#### 13.2.1 AMENDMENT TO SOUTHERN RIVER PRECINCT 3E STRUCTURE PLAN

For Council to consider endorsing a proposed amendment to the Southern River Precinct 3E Structure Plan.

**PROPOSED AMENDMENT TO SOUTHERN RIVER PRECINCT 3E  
STRUCTURE PLAN**

**STRUCTURE PLAN**

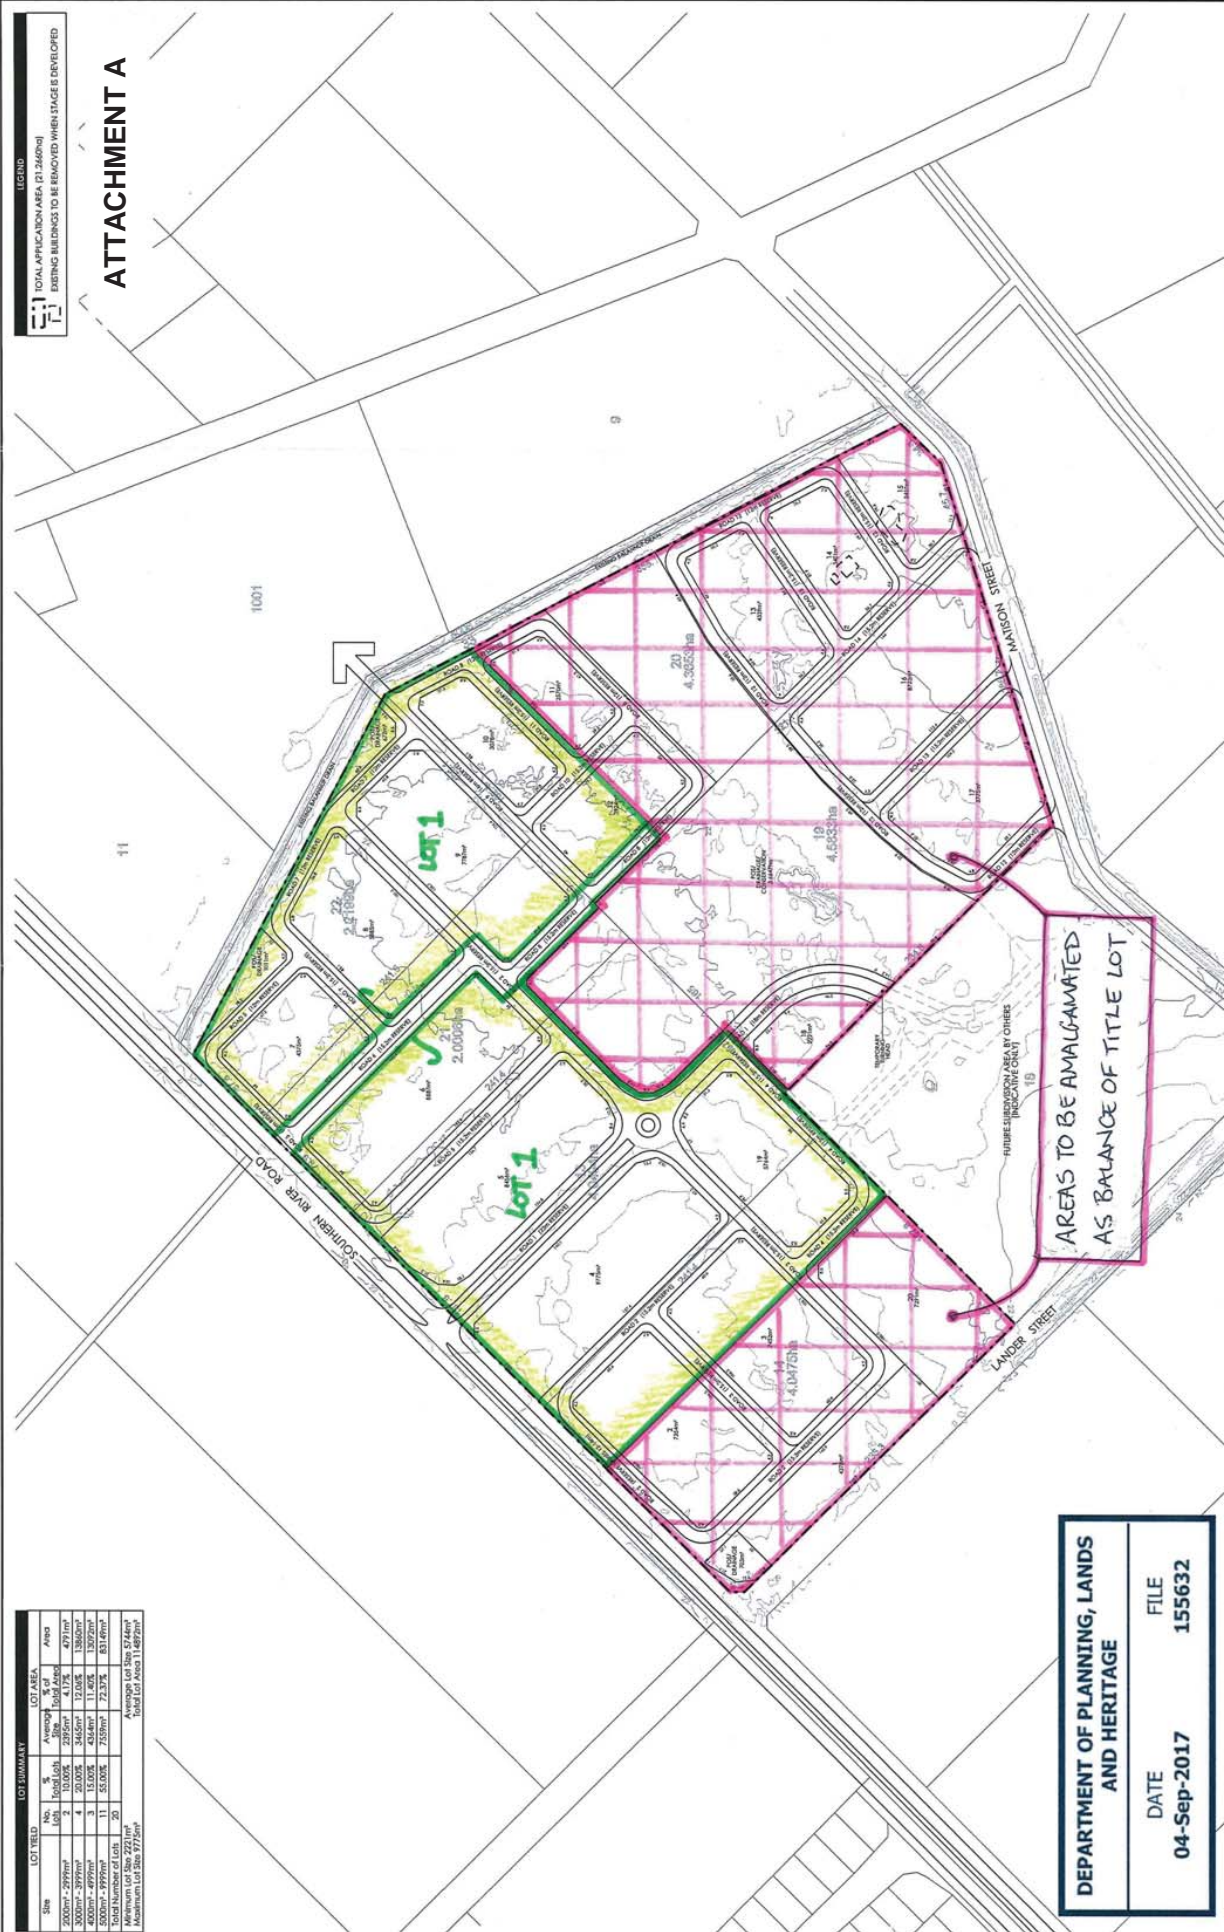
The draft Structure Plan proposes to increase the extent of the Residential R40-R60 designation, particularly within the northern corner of the precinct, and also within other discreet pockets of the site, as can be seen at attachment 13.2.1C.

The road network has been modified from the approved Structure Plan to provide additional laneways to support the increased density. A portion of laneways within the northern corner of the site are in a 10m wide loop formation. This is inconsistent with the standard 6m width for laneways provided by Liveable Neighbourhoods, but is also narrower than a standard access street. As such, the design of this road reserve should be supported by a cross section detailing what infrastructure constitutes the road reserve to justify the proposed widths. It is recommended the structure plan documentation be updated accordingly (**modification 5**).

The road immediately to the west of the Local Centre on the draft Structure Plan has been deleted, with a new road proposed further east to abut Lot 18. Whilst most of this road is contained within Lot 19 (the applicant's land), a small portion of road reserve is still contained within Lot 18. Given the unknown timing of the development of Lot 18, all roads abutting Lot 18 should be wholly contained within the applicant's land (including temporary and permanent turn-around areas and verges). Should the Commission accept the portion of road reserve within Lot 18, the draft Structure Plan documentation should be updated to provide dimensions of the width of the portion of road reserve within the Structure Plan area and the balance to be provided in the future (**modification 7**).

The draft Structure Plan does not detail the proposed location of nibs and slip lanes associated with the required new slip road from Southern River Road to access the Structure Plan area. These must be included on the Structure Plan Map **(modification 11)**, with the extent of the Other Regional Road reservation being contained within a future Metropolitan Region Scheme omnibus amendment once the intersection locations are confirmed and constructed. The Department of Planning Lands and Heritage has supported this approach.

The proposed Asset Protection Zone (APZ) contained in the BMP extends over a drainage basin (POS 3), which as mentioned above, cannot be considered low threat vegetation and therefore cannot be included in the APZ. The location of APZ should be revised to accommodate this area of classified vegetation, with all APZ areas meeting the required standards of *State Planning Policy 3.7 - Planning in Bushfire Prone Areas* (**modification 16**).

Summary of Submission	Comment
<p>3.4 The nibs and slip lanes associated with the new slip road should be noted on the LSP Map (preferably using dark blue hatching). The extent of the ORR reservation will be contained within a future MRS omnibus amendment once the intersection locations are confirmed and constructed.</p>	<p>Refer to Movement Network section of report.</p>
<p><u>Intersection Spacing</u></p>	
<p>3.5 Evidence should be provided by the applicant to demonstrate that the intersection spacing long the proposed central entry road (Road A on the LSP map) complies with the requirements of Liveable Neighbourhoods.</p>	<p>Noted. The applicant has provided information demonstrating compliance with the requirements of Liveable Neighbourhoods.</p>
<p><u>Road Reserve Widths</u></p>	
<p>3.6 Reduced road reserve widths are proposed adjacent to future reserves for recreation, drainage and/or conservation and where single sided development is proposed DPLH is supportive of the principle of reduced verges and road reserve widths being provided in the circumstances outlined above, provided that all required servicing infrastructure and on-street parking can be accommodated within the road reserve. Consideration should also be given to any potential level changes between the road pavement and the reserve areas. Appropriate space should be provided within the cross section to accommodate these level changes, where necessary.</p>	<p>Noted.</p>

<p><u>Proposed Temporary Turning Head</u></p>	
<p>3.9 The LSP Amendment identifies a temporary turning head at the edge of the area identified as being 'Subject to Further Planning'. DPLH recommends that this be removed and that the road interface in this location be reinstated as depicted on the existing approved LSP.</p>	<p>Refer to Movement Network section of report.</p>

5.	The Structure Plan Report and Traffic Report be amended to provide for a cross section for the 10m wide laneway.	To justify a proposed road width inconsistent with the WAPC's Liveable Neighbourhoods.

7.	The Structure Plan Report and Traffic Report be amended to provide dimensions of the width of the portion of road reserve adjacent Lot 18 and the balance of road reserve to be provided.	In accordance with the requirements of the WAPC's Structure Plan Framework.

11.	The Structure Plan Report and Map being modified to detail the proposed location of nibs and slip lanes associated with the required new slip road from Southern River Road to access the Structure Plan area.	to meet the requirements of WAPC's Liveable Neighbourhoods.
